# Rowa Fashions Limited Unit-2

2 September 2024

## 2. Observation

**5.12.2 Frequency of Testing**

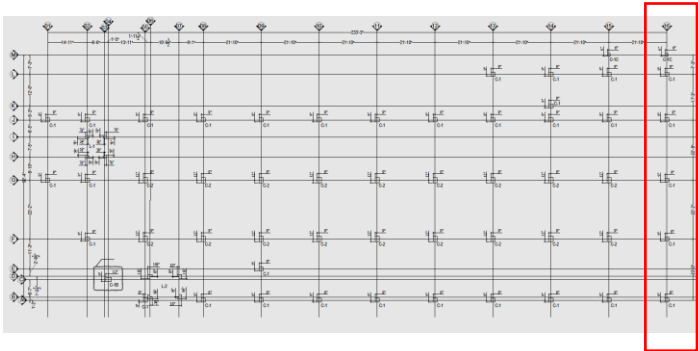
**Description:** The number of concrete cylinder test reports didn't meet BNBC's frequency of testing requirements (section 5.12.2). The design strength for the beam is 3500 psi but no design strength was mentioned in the drawing for columns.

Moreover, some cores (beam & column) were taken but no test reports were available. The building engineer is required to verify in-situ concrete strength to confirm the design strength.

Typical column layout

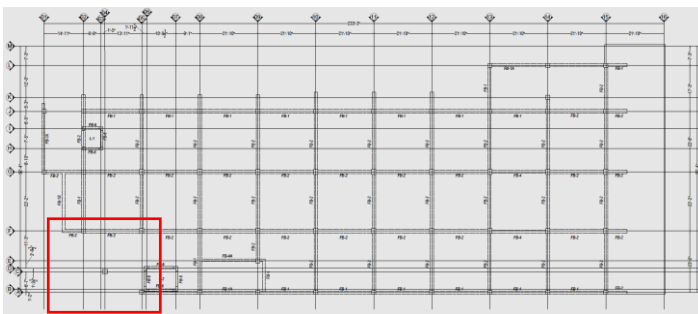
Utility portion columns only ground level

**Description:** In the provided as-built drawing column layout and schedule shows that marked columns (Utility portion) run from top to bottom. But practically these columns are only at ground level.

**Description:** The first-floor beam layout is different than shown in the provided drawings. The building engineer is required to survey the full structure and prepare complete as-built structural drawings. Also, provide construction drawings as the reference for the foundation.
